ITEM 4. DEVELOPMENT APPLICATION: 130-134 ELIZABETH STREET SYDNEY**FILE NO: D/2014/58****DEVELOPMENT APPLICATION NO: D/2014/58****SUMMARY****Date of Submission:** 17 January 2014**Amended:** 14 May 2014**Applicant:** CBUS Property**Architect:** Kann Finch**Developer:** CBUS Property**Owner:** CBUS Property 130 Elizabeth Street Pty Ltd ATF 130 Elizabeth Street Unit Trust**Cost of Works:** \$105,600,000**Proposal Summary:** The proposal seeks consent for a Stage 1 concept proposal, including the following:

RECOMMENDATION

Figure 21: An axometric drawing of the amended building envelope incorporating the additional height (to 120.5 metres) and the chamfered southwestern corner

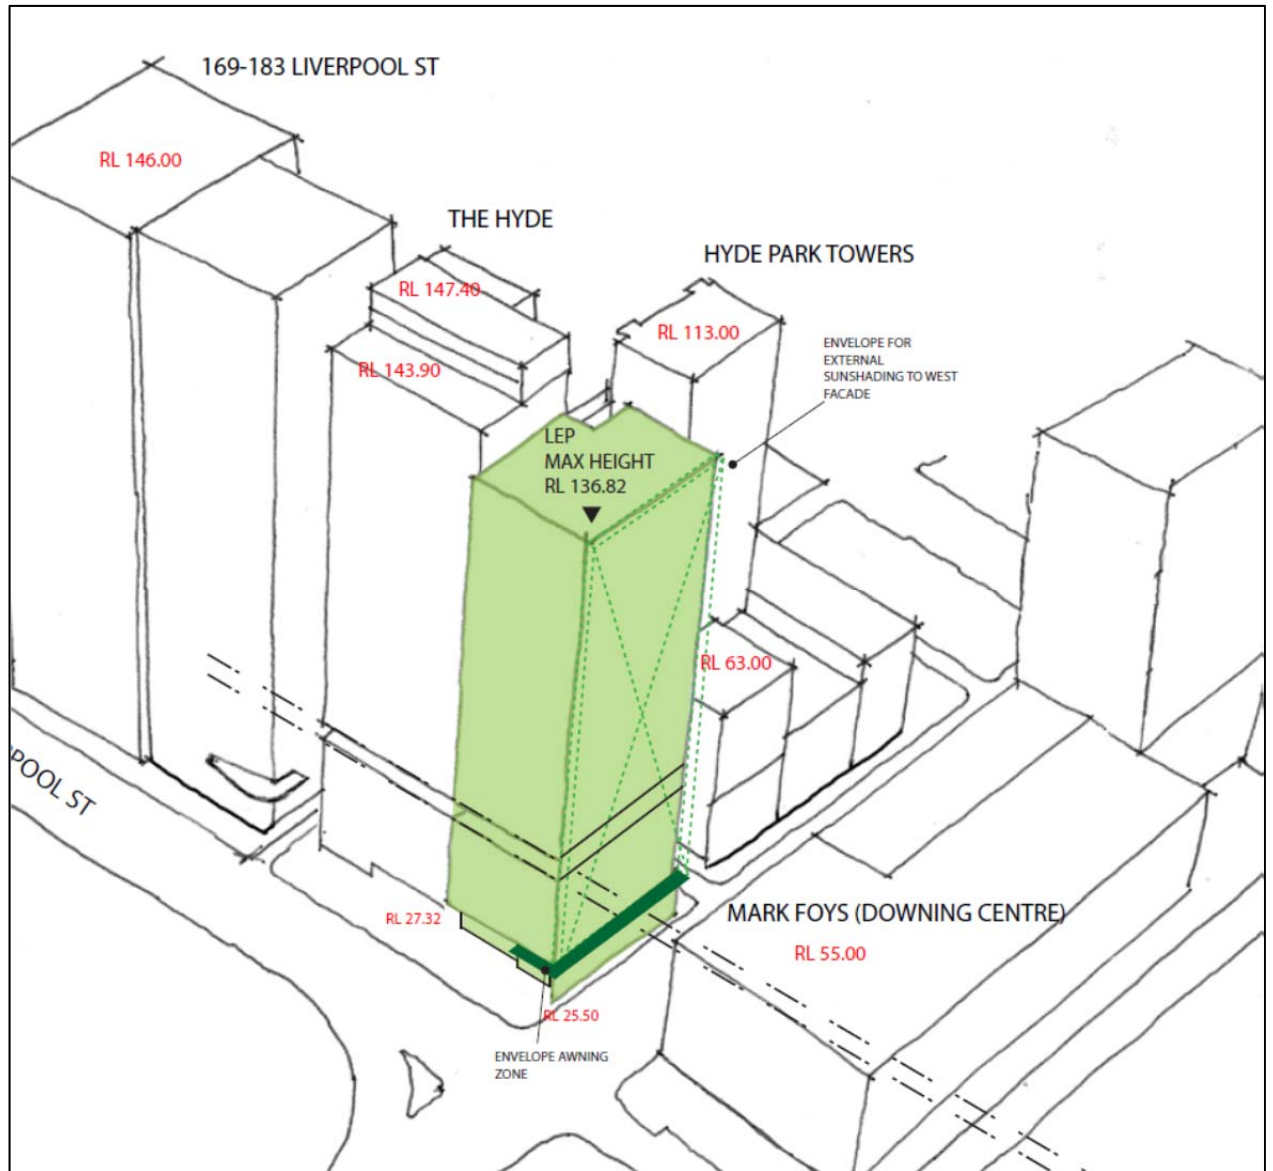
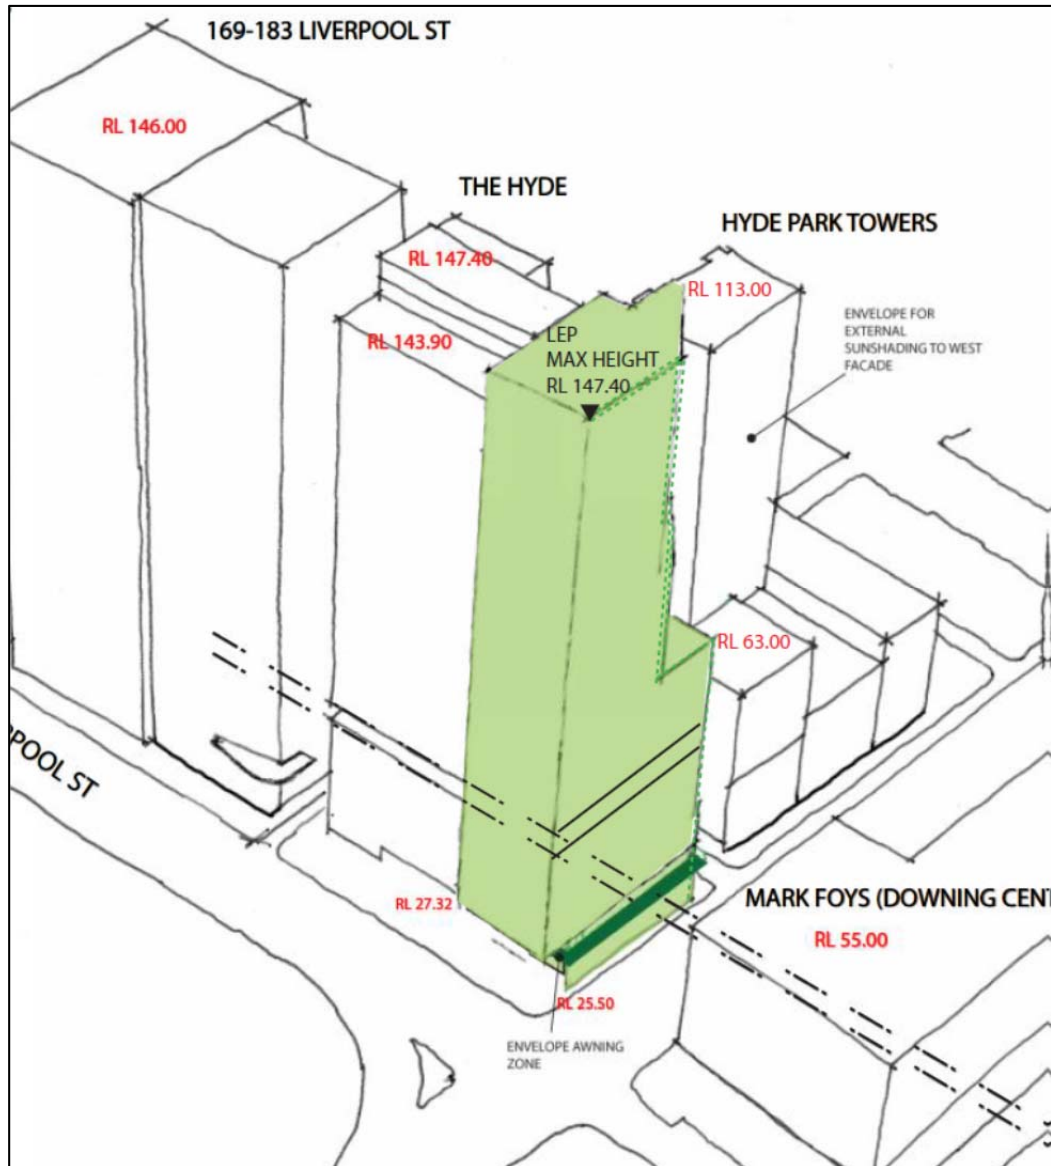
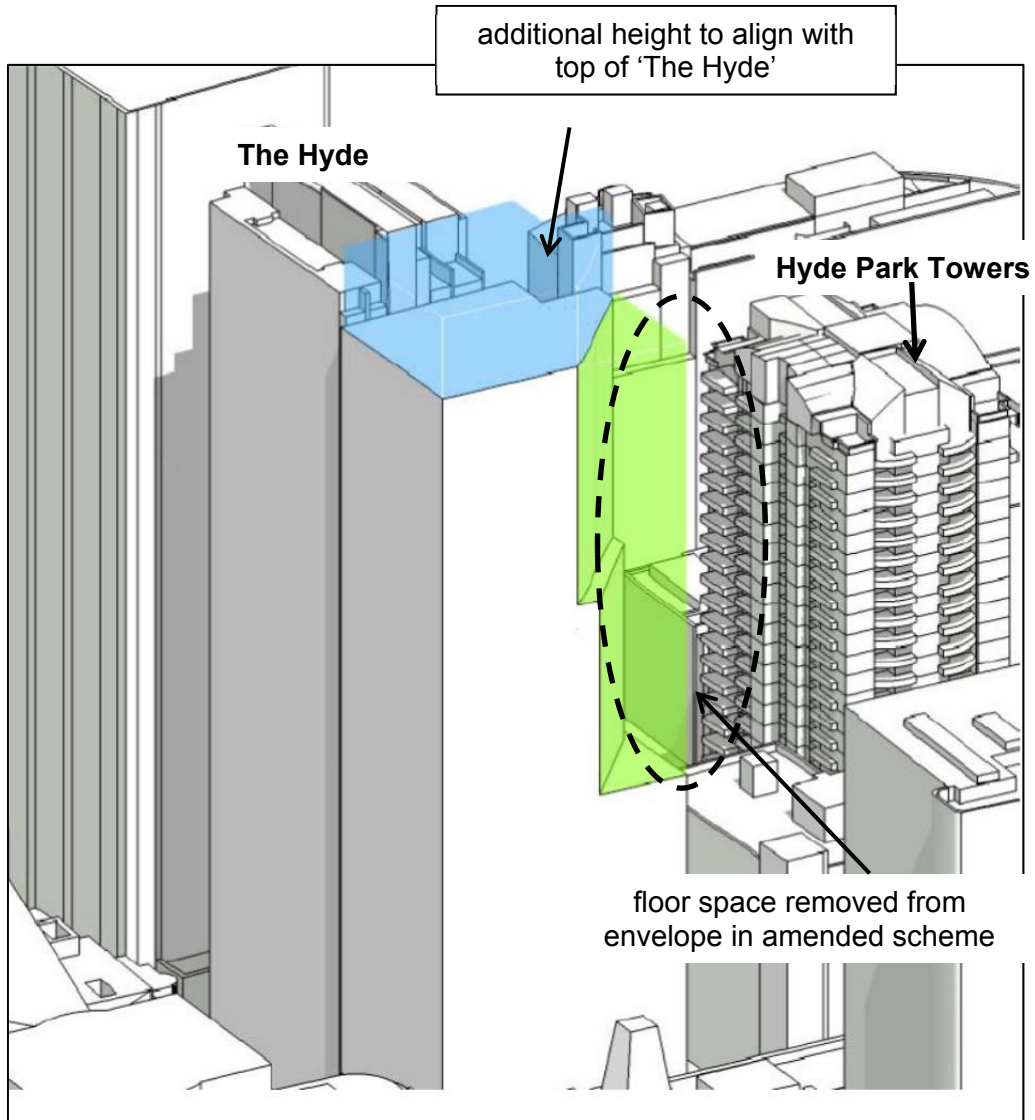
48. This amended scheme provides an alternative design response to the site by chamfering off the southwestern corner of the envelope on Levels 14 to 36 to create a more slender tower form. **Figures 18 to 21**, below, illustrates a comparison of floor plates and envelopes between the originally lodged scheme and the amended proposal.

49. In order to retain the yield of the originally envelope, the Applicant is seeking to increase the height of envelope by 10.5 metres to a maximum height of 120.5 metres (RL 147.40). **Figure 22**, below, illustrates the areas where the chamfered edge is proposed, and the additional height sought to the envelope to accommodate the redistributed floor space. This height would align with the top of the architectural roof feature of 'The Hyde' building located to the east of the site.

Figure 23: View of the northern elevation of proposed building envelope illustrating the extent of technical breach to the building height development standard

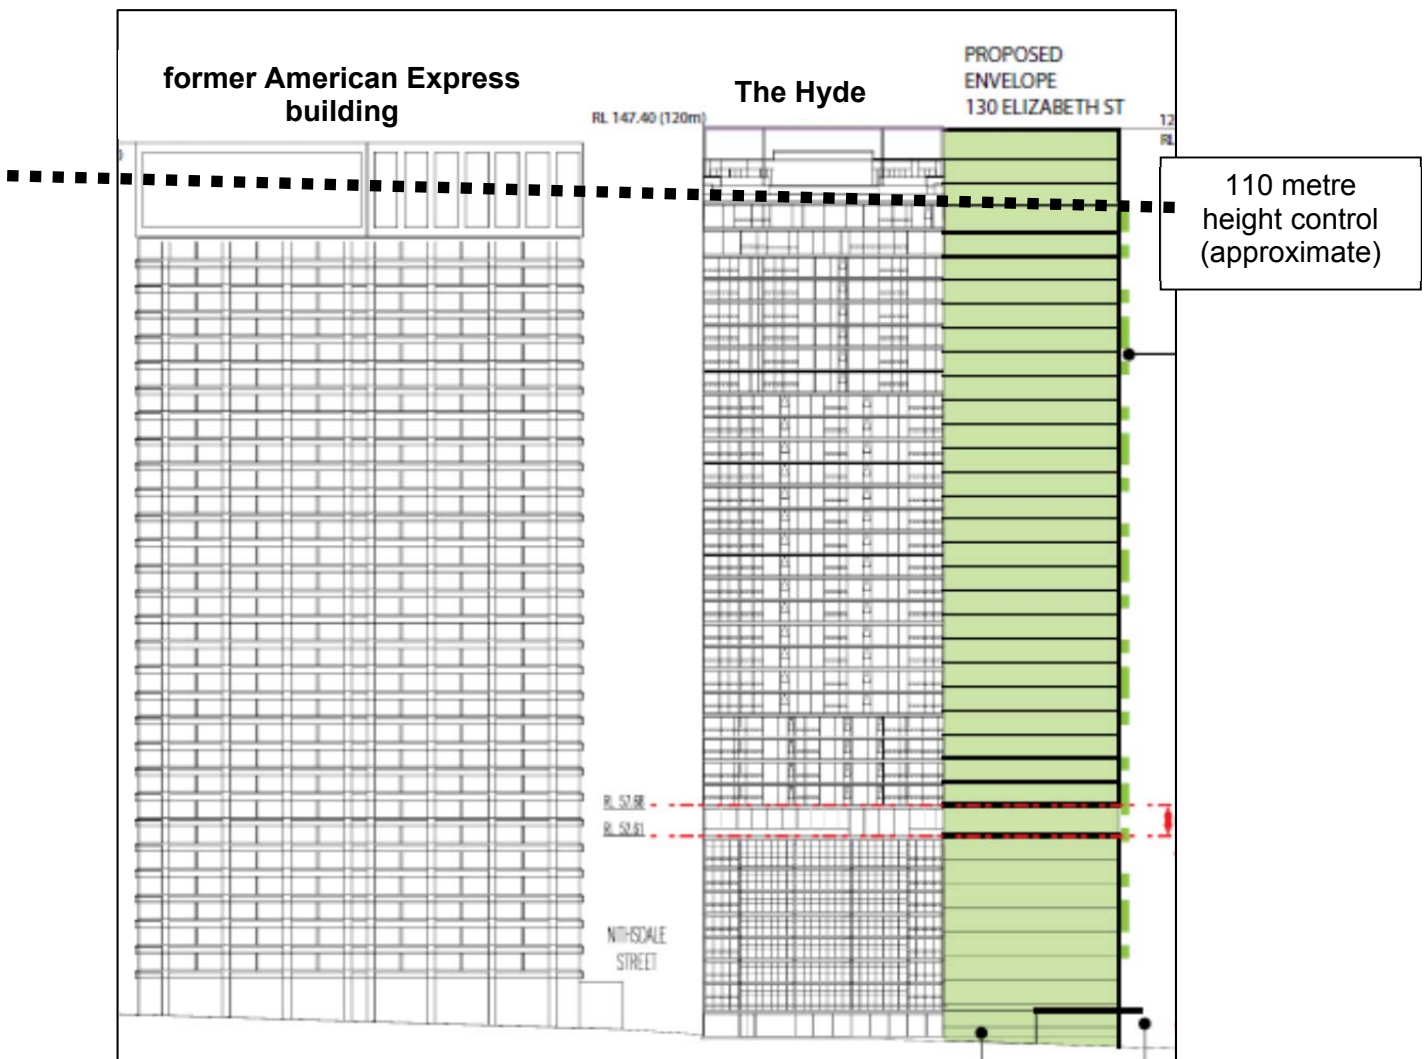
- 57. The amended proposal seeks to increase the maximum height of the building envelope to 120.5 metres. This results in a technical variation from the development standard by a maximum of 10.5 metres or a 9.5% variation. The applicant is relying on the provisions of Clause 4.6 of SLEP 2012 to vary the height development standard by a maximum of 10.5 metres.
- 58. **Figures 23 and 24**, below, illustrate those elements of the building envelope that are in breach of the building height development standard.

Figure 25: The proposed building envelope in its Liverpool Street context, noting that these buildings do not contain a street frontage height/podium

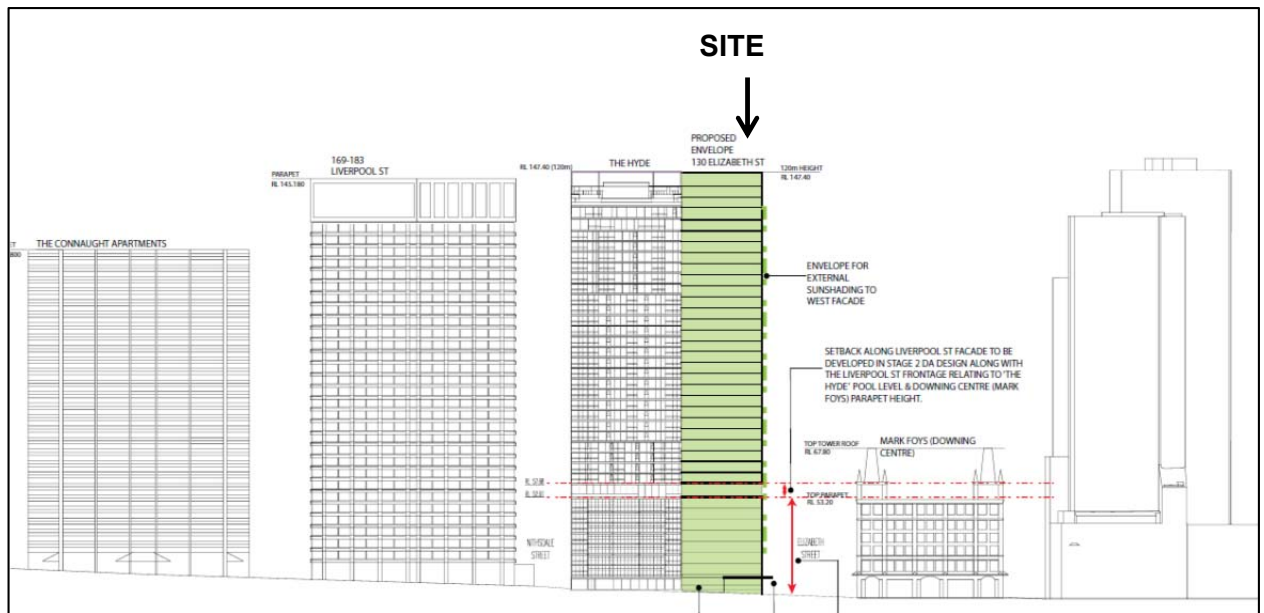
- (a) the proposed lack of a street frontage height on this site is contextually appropriate due to the established development pattern of buildings along Liverpool Street. The site's immediate neighbours to the east have been developed over a number of decades, and whilst all these sites have different street frontage widths and architectural styles, all have been developed with no podium and present a consistent setback pattern to the street. The continuation of this development pattern will provide definition to the public domain and strengthen the sense of enclosure to Hyde Park, which are desired elements for this Special Character Area as noted in SDCP 2012. **Figures 25 and 26**, below, demonstrate an analysis of this Liverpool Street context;
